DAM SAFETY PHOTOGRAPHS

DAM NAME: MUNDAY_HANEY
65-13410

**BEFORE THE DEPARTMENT OF WATER RESOURCES
OF THE STATE OF IDAHO**

**PRELIMINARY ORDER
VOIDING PERMIT**

SKETCH OF DAM SHOWING LOCATION OF SPILLWAY AND OUTLET WORKS AND ANY MAINTENANCE PROBLEMS:

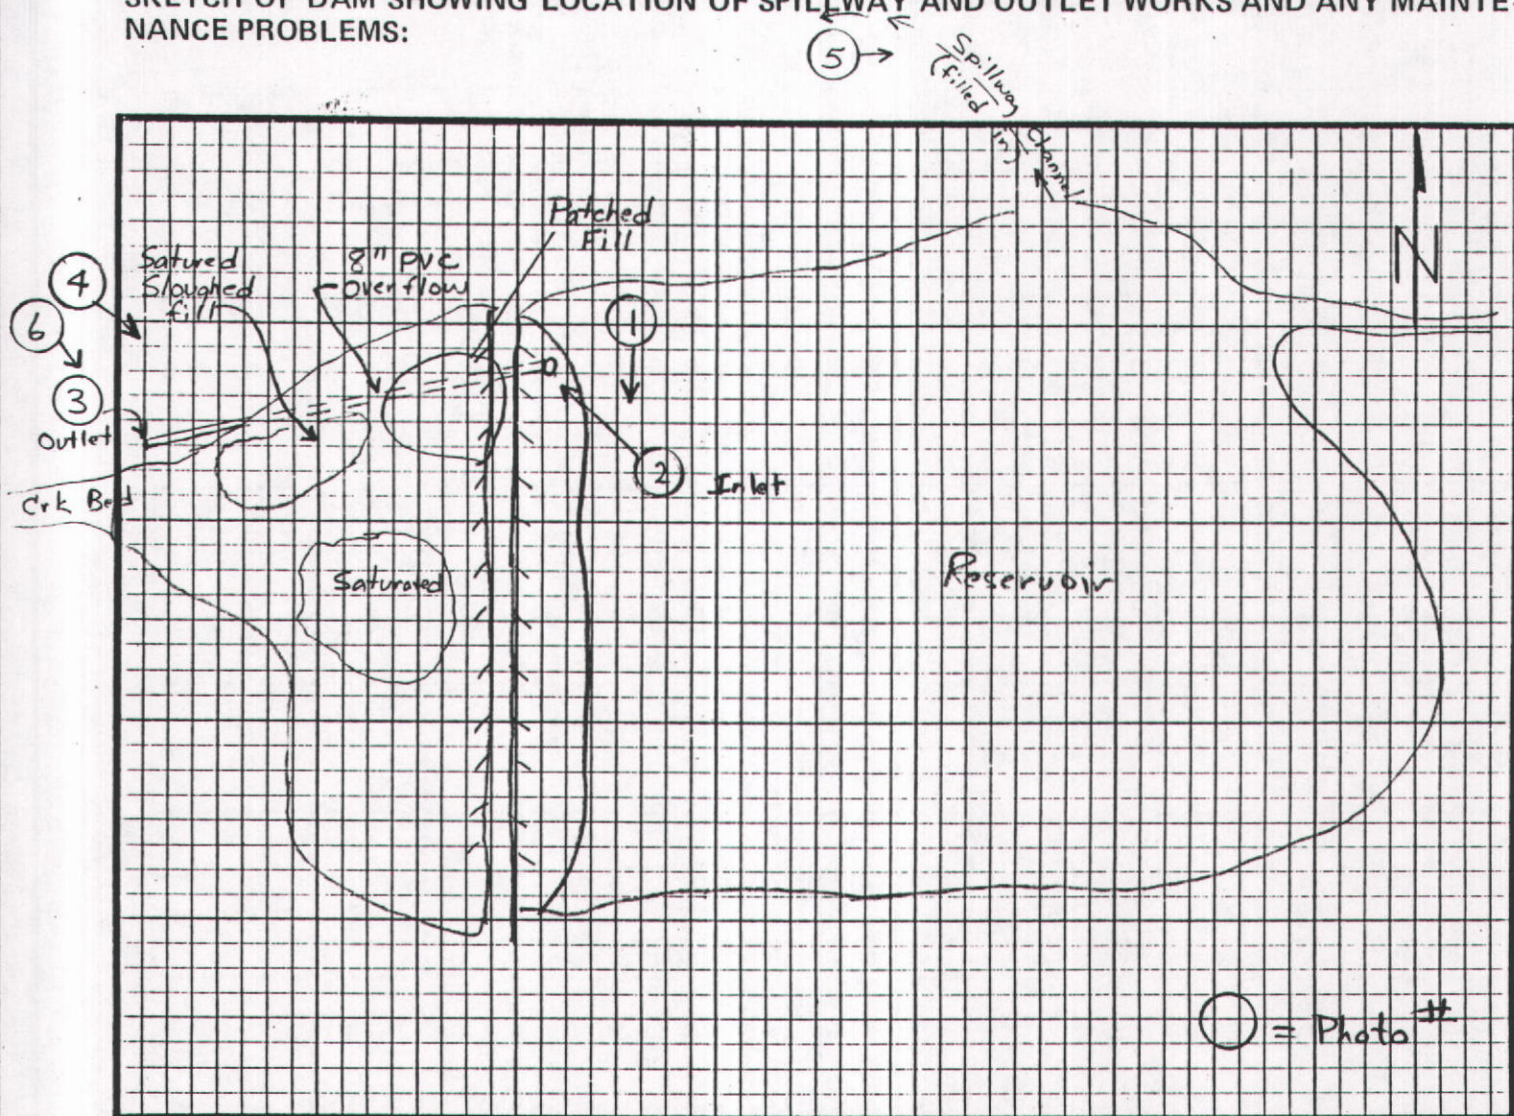
GENERAL CONDITION AND DESCRIPTION OF DAM: Poor, it appears nothing has been done to decrease seepage through the embankment. An 8" PVC overflow pipe has been installed near the right abutment, which provides 4.8 ft of freeboard. No low level controlled outlet has been installed. The spillway channel has been filled-in off the right abutment. It appears the upper ^{right} downstream slope has been overtopped or sloughed away, as a new fill patch has been added (photo #4). Area is saturated and unstable.

The Crest of the embankment, and previous spillway channel area were surveyed.

Cal. Est. overflow pipe capacity $\approx$ 7 CFS.

Q100 IDF = 17 CFS

RECOMMENDATIONS: Removal of the reservoir and embankment.

The facility does not meet basic dam safety provisions

Munday - Haney Dam.
 D65-XX26
 Survey by JFW, GB
 5/13/93

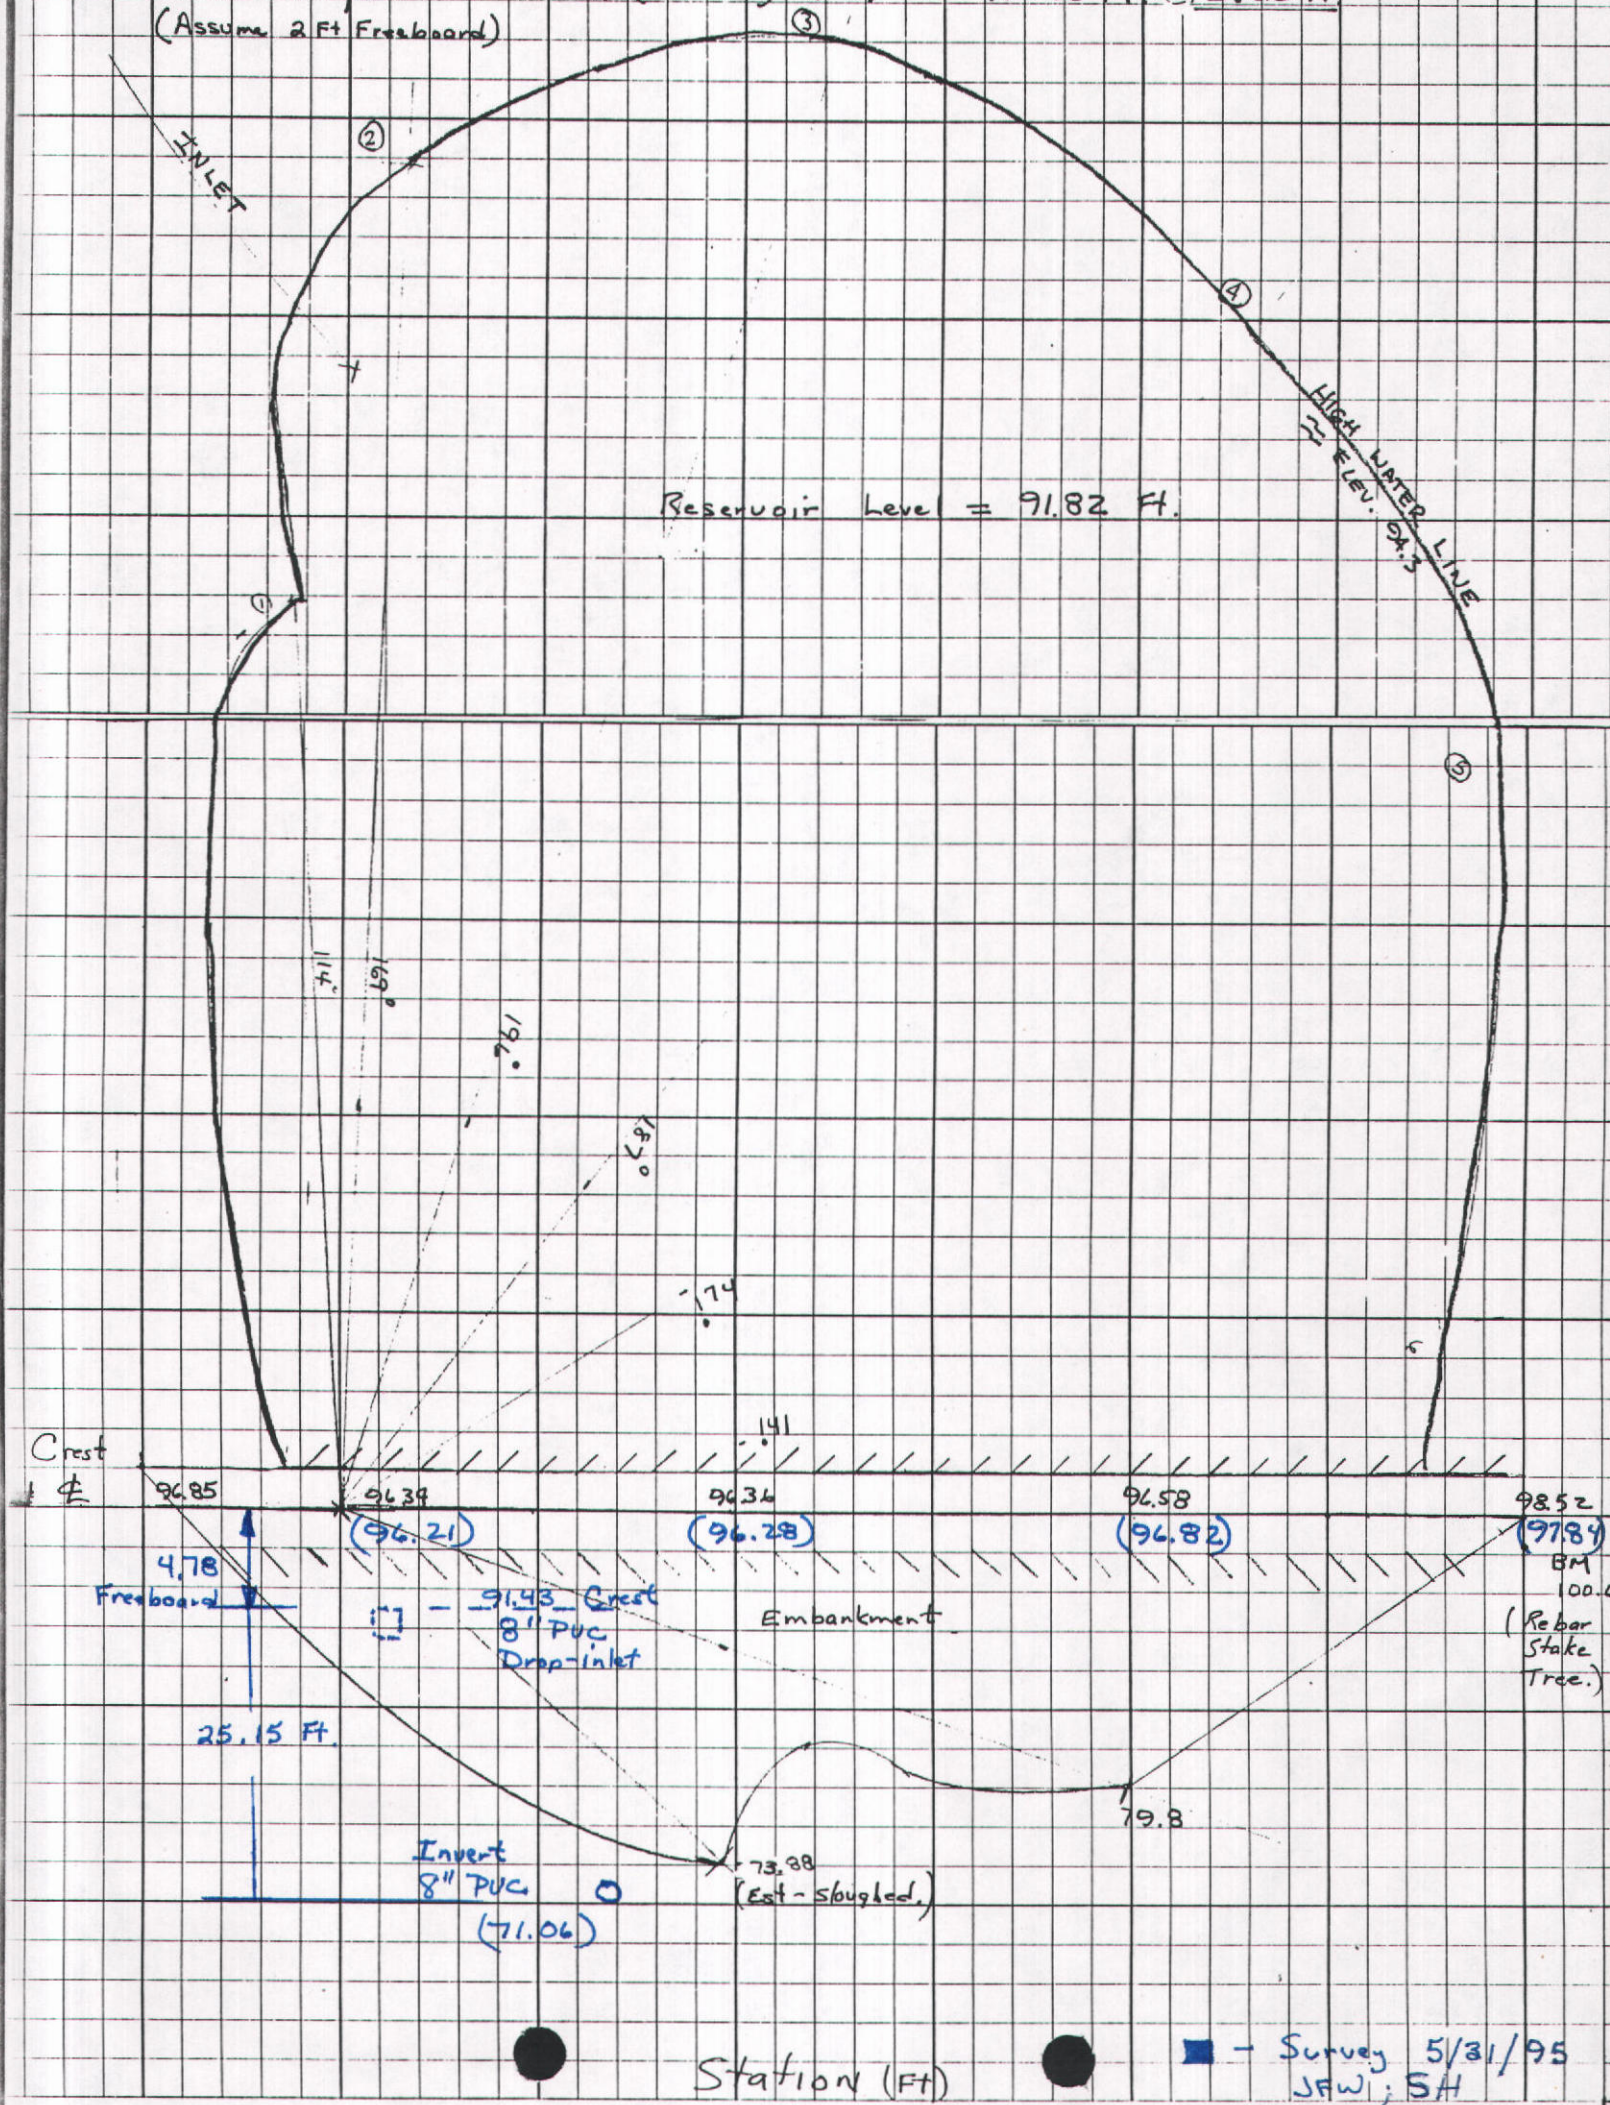
Reservoir Surface Area = (998 sq.) (25 sq. ft./sq.) / 43,560 ft²/ac. = .57 ac ≈ .6

Dam Height = 22.7 Ft.

Est. Storage = (20.7 Ft.) (.6 ac) (.4) = 4.9 ac-ft ≈ 5. ac-ft
 (Assume 2 Ft Freeboard)
